Cambridgeshire Guided Busway

Report on Guideway Defects and Corrective Measures

Cambridgeshire Guided Busway
Cambridgeshire County Council v BAM Nuttall Ltd.

| Date | : | 11 September 2014 |

Figure 3. Photograph of a foundation pad upon which there are more than 35mm of shims.

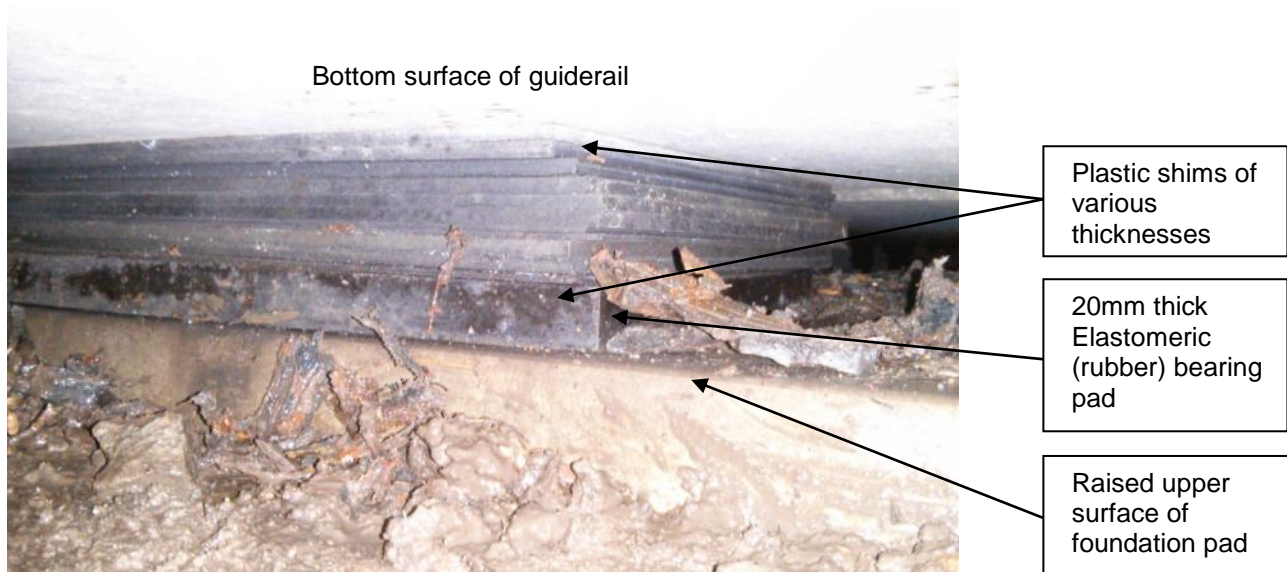
12. BNL's design included for there to be 10mm of shims in place on construction and permitted a maximum of a further 25mm to be placed if necessary. Limited exploratory excavations to examine the bearings and shims along the site, where no previous adjustments have been made, have shown that the depth of shims present is variable where shallow foundations are present. We believe this reflects corrections to the level of the guideway undertaken by BNL prior to handover to the Council. The depth of shims occasionally exceeds BNL's design limit of 35mm as can be seen in the photograph below.

Figure 4. Photograph of a 'fixed' joint longitudinal restraint bracket

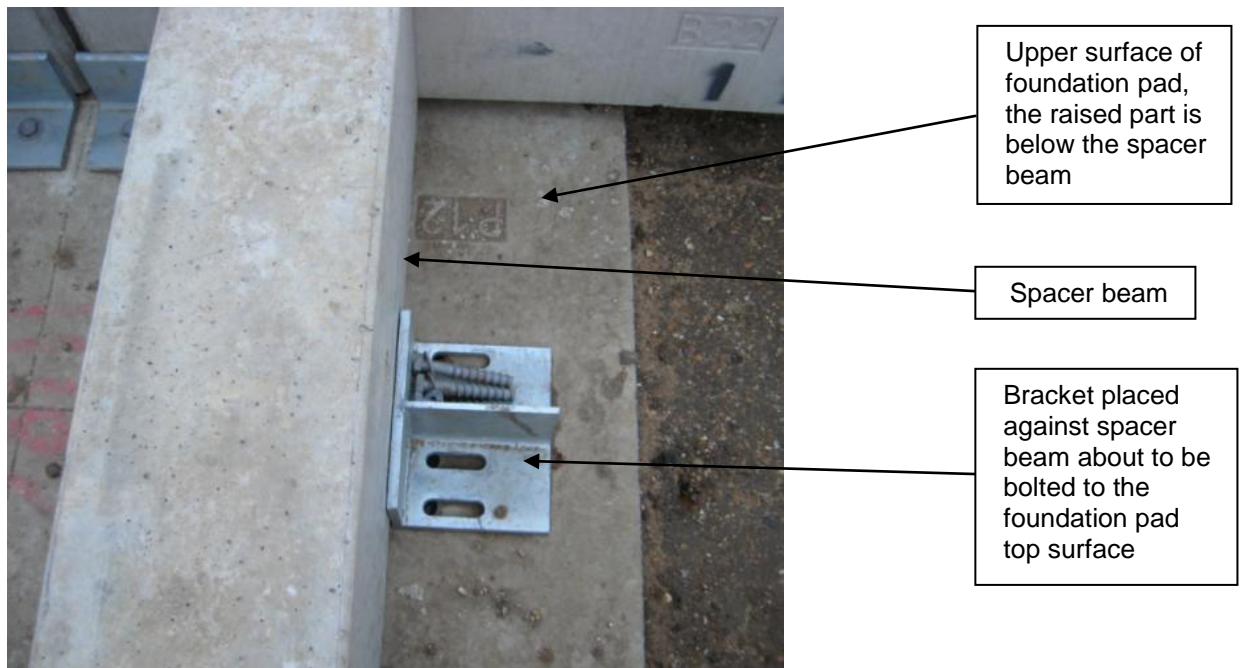
32. In addition, because the restraint bracket rests against the spacer beam at the bottom (see photograph at Figure 4 above), there will be a rotating force (torsion) applied to the spacer beam when the buses brake or accelerate. There is insufficient friction to resist this and this causes the spacer beams to rotate as may be seen in these photographs below.

33. The longitudinal restraint brackets have slotted holes (see photographs at Figure 4 above and here) and the fixings therefore rely on friction being generated by tightening of the bolts. We have calculated that the bracket bolts (which are screwed into plastic sockets in the foundation concrete) cannot be tightened sufficiently to generate the required friction.
34. Defect 294 has been notified because, for the above reasons, there is a lack of longitudinal restraint which is contrary to the intended design.

Figure 10. Fixed end detail

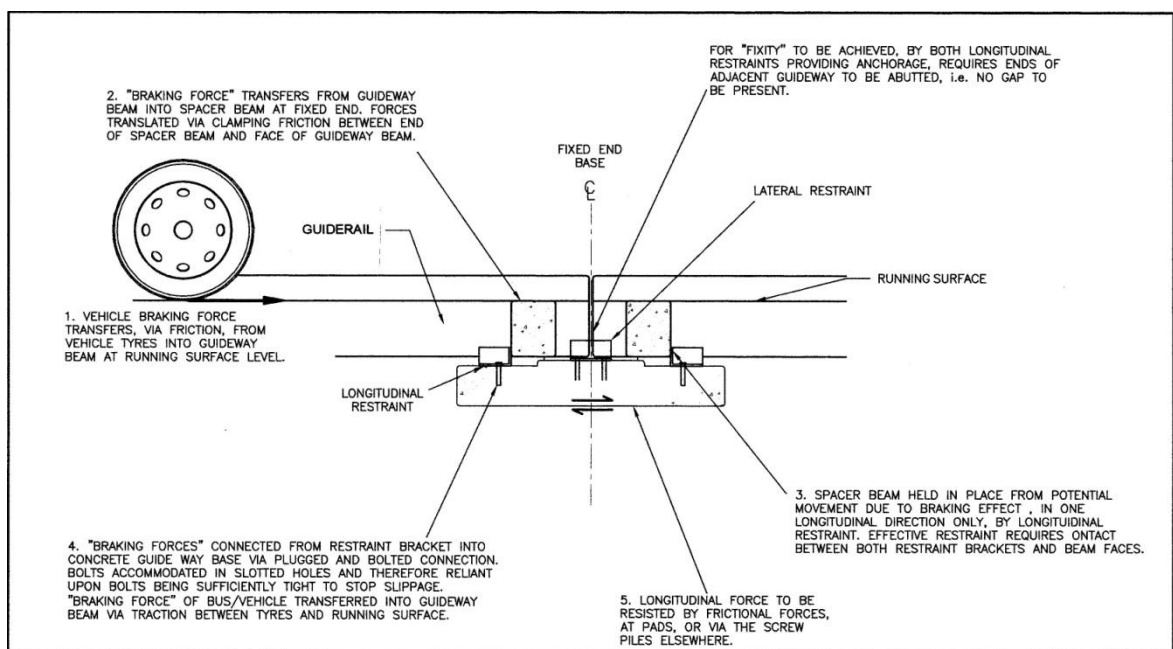
36. As indicated at §15 above, longitudinal restraint at the fixed ends was supposed to be provided by brackets bolted to the pad foundations or pile cap and abutting the outside of the spacer beams as shown in Figure 4 and Figure 9 above and in the diagram at Figure 10 below. Fixity in a longitudinal direction is then only achieved if:

- (i) The guidrails actually abut each other;
- (ii) The connection between the spacer beams and the guidrails is capable of transferring (by friction) the braking force of 240 kN from the guidrail into the spacer beams; and
- (iii) The bolting down of the brackets ensures that the brackets do not move under the applied braking force, and the bracket actually abuts the spacer beam.

Figure 11. Photograph of guiderails not abutting, and spalling in a location where they do abut.

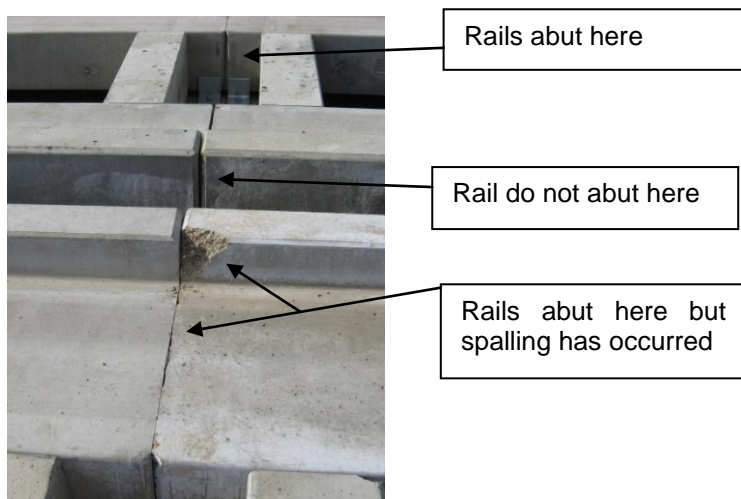
37. Issues (ii) and (iii) are dealt with at §31 to §34 above and Defect 268 relates to the fact that there are situations in which guidrails at fixed ends do not abut one another.
38. Where the guidrails do not touch and there are gaps at the joint, therefore, there is lack of longitudinal restraint.

39. Where the guiderails do touch, however, there is the risk of spalling because of localised pressure points.
40. In addition there is the likelihood of foundation movement (up and down) and this will cause rotation to occur at the joints. If the guiderails are touching, either the guiderails will be forced apart with the restraint brackets sliding in their slotted holes or spalling of concrete will occur as has occurred here (Figure 11 and Figure 12). Examples of spalling and failed spalling repairs are also shown in Appendix C.

Figure 13. Photograph of a guiderail that has moved to the left, and that now does not abut the lateral restraint bracket.

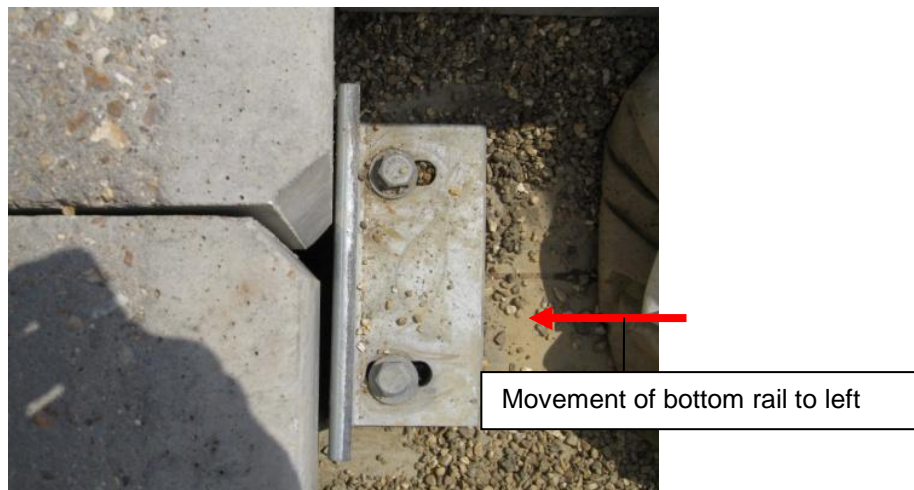
42. Defect 288 has been notified because steps have formed in the guiderail faces caused by lateral movement of the guiderails. Such movement means the lateral restraint brackets, which, like the longitudinal restraint brackets, contain slotted holes (see Figure 13 below).

43. This means that again there is reliance upon friction between the brackets and the foundation and evidently this is insufficient. According to Defect Notification 288A, steps of up to 7mm have been observed. See photographs in Appendix C (starting on page 67).

Figure 15. Photograph showing displaced shims and bearing pad.

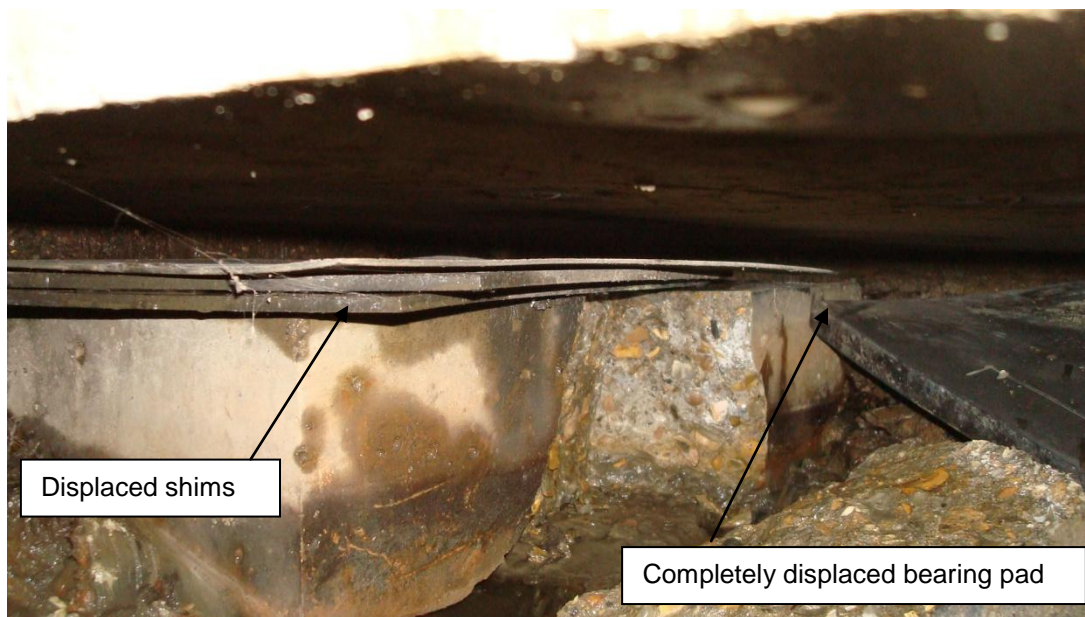
44. These defect notifications relate to the foundation at a change in depth of the concrete guiderails (the interface between Type 1 and Type 2 beams³). At these locations, a precast concrete support block has been provided beneath the thinner Type 2 beam to make up the difference in depth.
45. Photographs show that this support block has failed resulting in movement of the bearings/shims. The spacer block is unstable, being loosely laid on the precast foundation pad, and cannot transmit the loads adequately, evidenced by failure. In our opinion, the precast spacer block should have been bedded on epoxy mortar. This is illustrated in the photographs at Figure 14 and Figure 15 below, which also show slippage of shims and displaced bearing pad.

Figure 16. Photograph of a displaced bearing pad (left) and slipped shims (right).

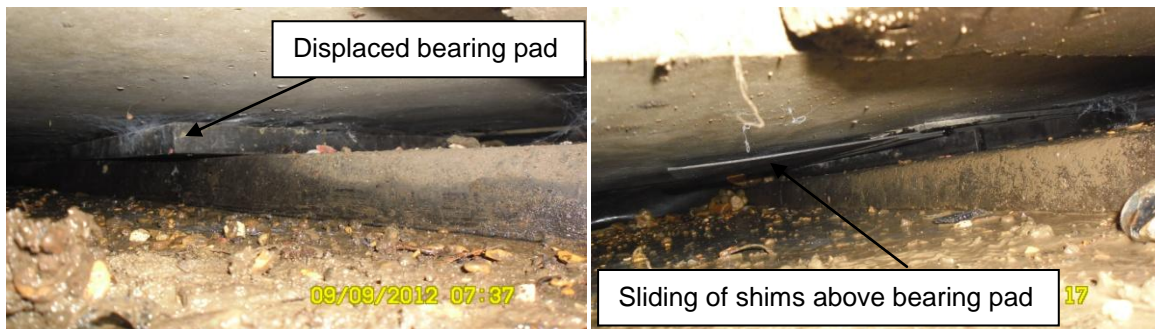
46. These defect notifications relate to the slippage of bearing pads and/or shims from their intended positions resulting in steps in the running surface and see-sawing of the guiderails.

47. In our opinion, the reason for the slippage is a combination of lack of longitudinal and lateral restraint of the guideway coupled with the repeated cycles of expansion and contraction of the guidrails. The bearing pads and shims are not fixed in place in any way and rely on friction to retain them in position. We have calculated, however, that there is insufficient vertical load to generate the required friction.
48. This problem is likely to be repeated many times during the design life of the guideway unless a permanent solution is implemented.

Figure 20. Cross section showing non-connection of drainage

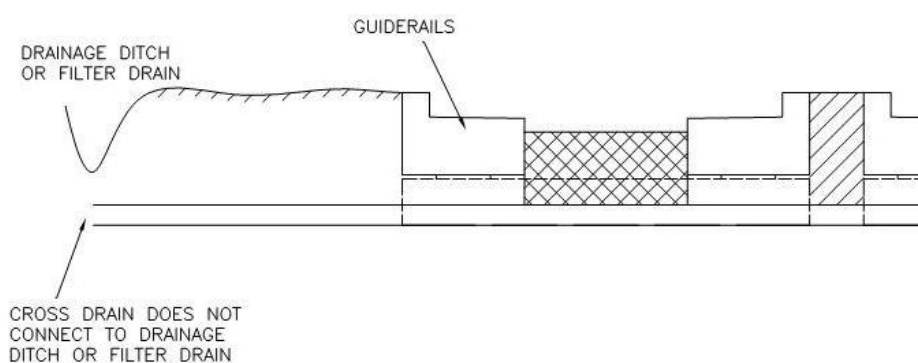
54. Defect 292 has been notified in respect of non-functioning infiltration drains over a length of guideway (between chainage 17+530 and 17+710) in the vicinity of Bridge Road Bridge, Histon. Standing water occurs around the guide tracks. Investigations arranged by the PM have shown that the cross drains do not connect with the longitudinal side drains which, in part, act as infiltration trenches. These trenches are either insufficiently deep for the connection of the cross drains or the cross drains do not extend sufficiently to connect with the side drains. The construction does not comply with the accepted design.

FIGURE 1: INDICATIVE ARRANGEMENT OF GUIDERAIL SUPPORTS

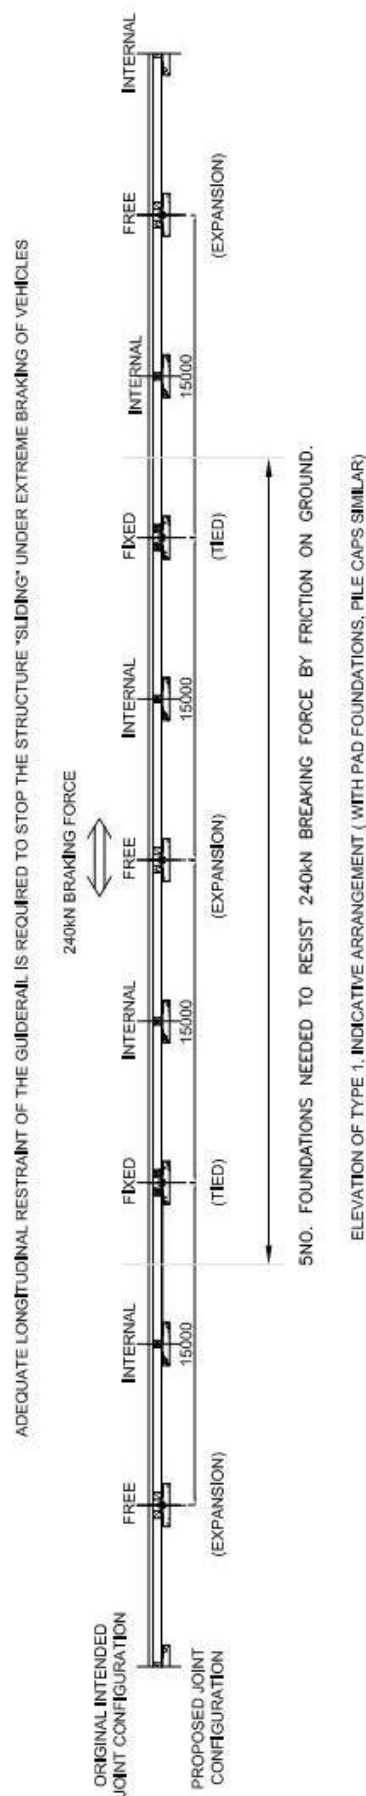
LACK OF LONGITUDINAL RESTRAINT PROVIDED AT "FIXED" SUPPORT JOINTS BY THE FOUNDATIONS/ SUBSTRUCTURE, A SINGLE "FIXED" SUPPORT IS INADEQUATE TO RESTRAIN THE MAXIMUM REQUIRED LONGITUDINAL (BRAKING) FORCES. THESE FORCES NEED TO BE DISTRIBUTED AND SPREAD OVER NOMINALLY FIVE ADJACENT FOUNDATIONS SUPPORTS. REPLACEMENT BEARINGS AND SHIMS TO BE PROVIDED AT ALL SUPPORTS TO FACILITATE THE TRANSFER OF THE LONGITUDINAL, AS WELL AS THE TRAVERSE, FORCES FROM THE GUIDERAILS DOWN INTO THE FOUNDATIONS. ALSO REFER TO FIGURES 2 AND 3.

111. Because the pad foundations are unable individually to accommodate the design braking force of 240 kN and because we have calculated that 5 foundations are needed, the bearing and shim detail has been revised so that all bearings/shims carry an equal proportion of the braking force. This also deals with some of the other defects. Essentially, therefore, the guiderail system will ‘float’ on the elastomeric bearing pads and will be restrained horizontally (i.e. longitudinally and laterally) by the resistance of the pads to shear forces.

112. The proposed detail is shown in Figures 1, 2 and 3 in Appendix G.
113. Current indications given to us by Ekspan, the manufacturer of the bearing pads, are that the existing bearing pads are adequate to accommodate a longitudinal force of 20 kN (working load), 25 kN lateral load (working load) and up to 213 kN vertical working load. The minimum serviceability permanent load is 17.5 kN and serviceability transient live load is 11.3 kN on the bearings, which means low friction is available on the bearing pads and shims. Because there is insufficient friction available to retain the bearing pads and shims in place and to transmit the shear forces generated by braking loads and thermal effects, we propose to bond the pads/shims in place as shown in the Figures 1 to 3 in Appendix G. The arrangement permits the insertion of additional shims should settlement occur to the foundations and, similarly, they may be removed should heave occur.

FIGURE 6: INDICATIVE PILE CAP AND RAKE PILING ARRANGEMENT

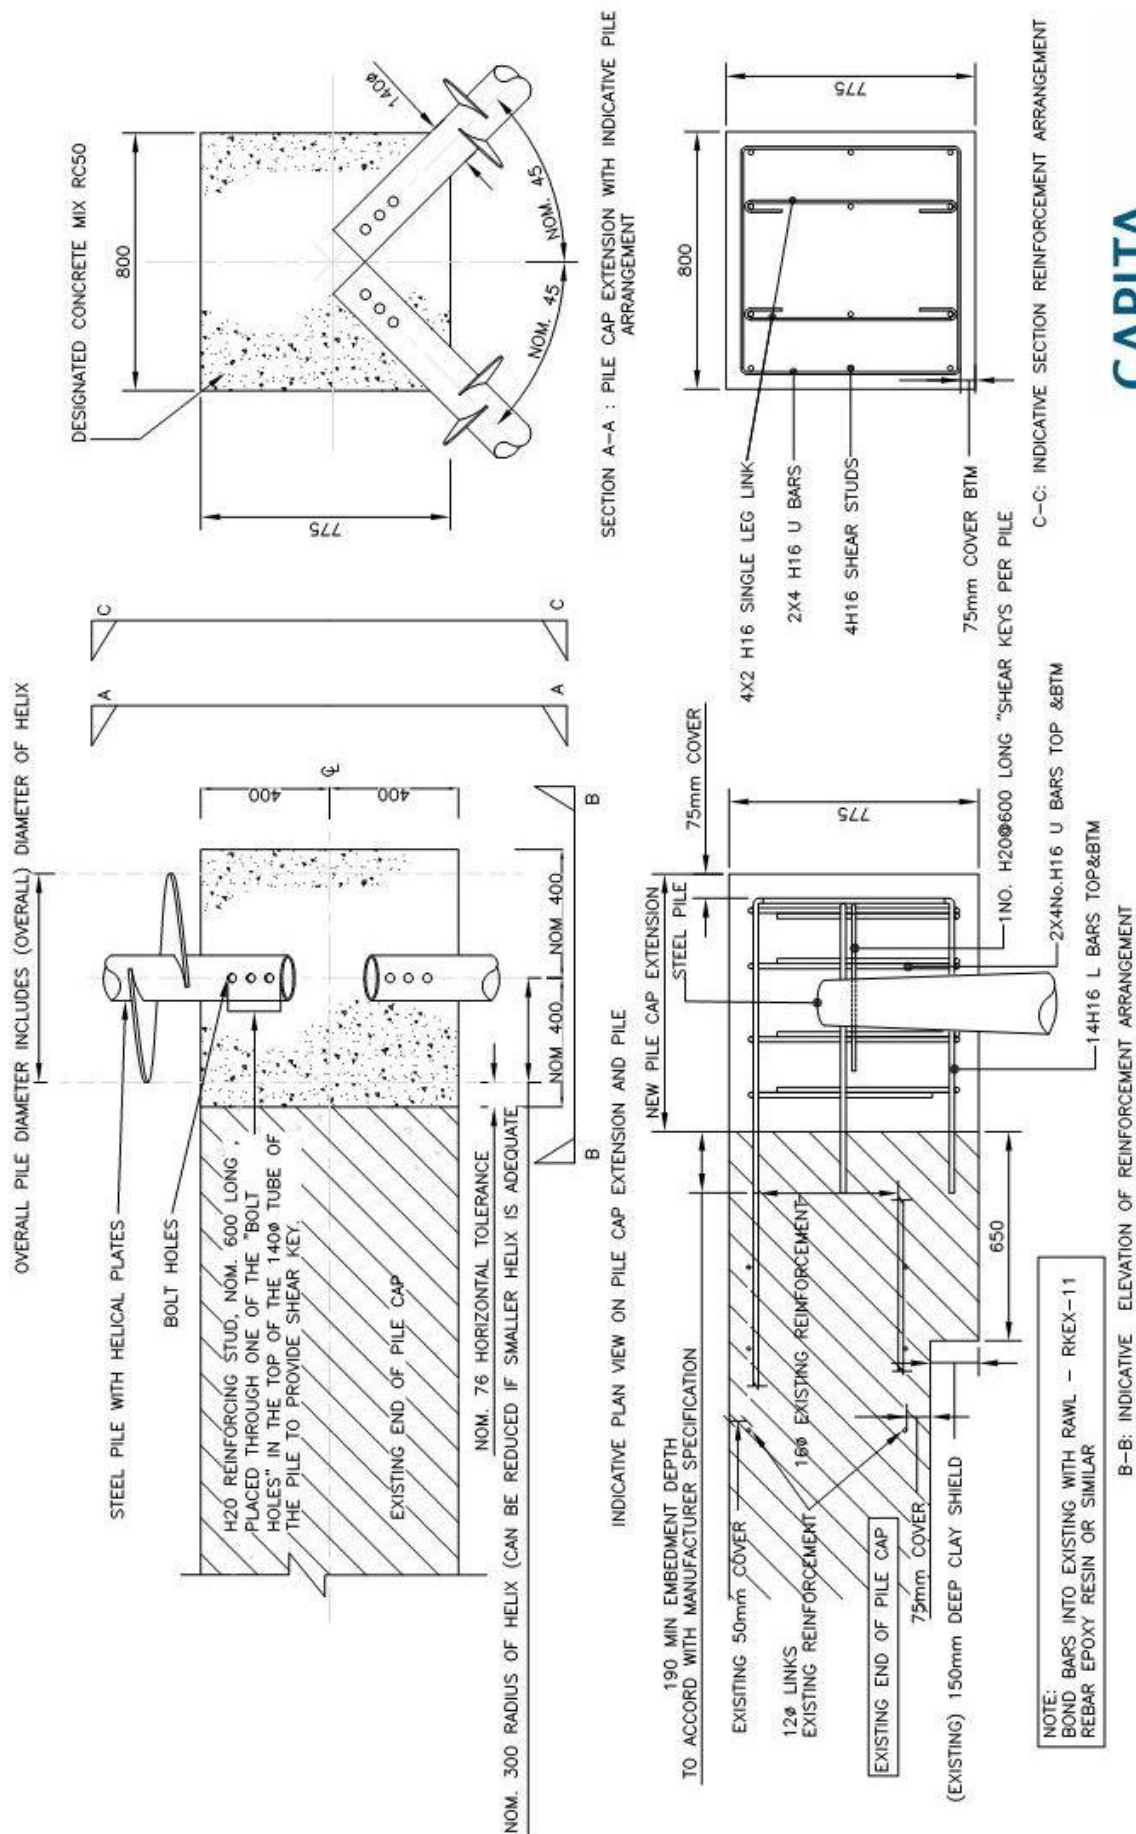
119. As with the pad foundations, the pile caps are incapable of accommodating the design braking force of 240 kN and we have calculated that the screw piles are so flimsy in a horizontal direction that a single pile can only provide restraint to a horizontal working load of 9 kN longitudinally with the deflection of the top of pile cap limited to 10mm. Maintaining the same principle as the pad foundations in sharing the braking loads over 5 pile caps (or over 5 combinations of pile cap and pad foundation), the bearing pad/shim arrangement will be the same as for pad foundations.

120. We propose that each pile cap be stiffened to resist a load of 80 kN by two raking piles at each end of the existing pile cap, the tops of which are connected to the pile cap by an extension of the cap formed in situ concrete resin anchored to the existing concrete. The arrangement is shown in Figure 6 in Appendix G.
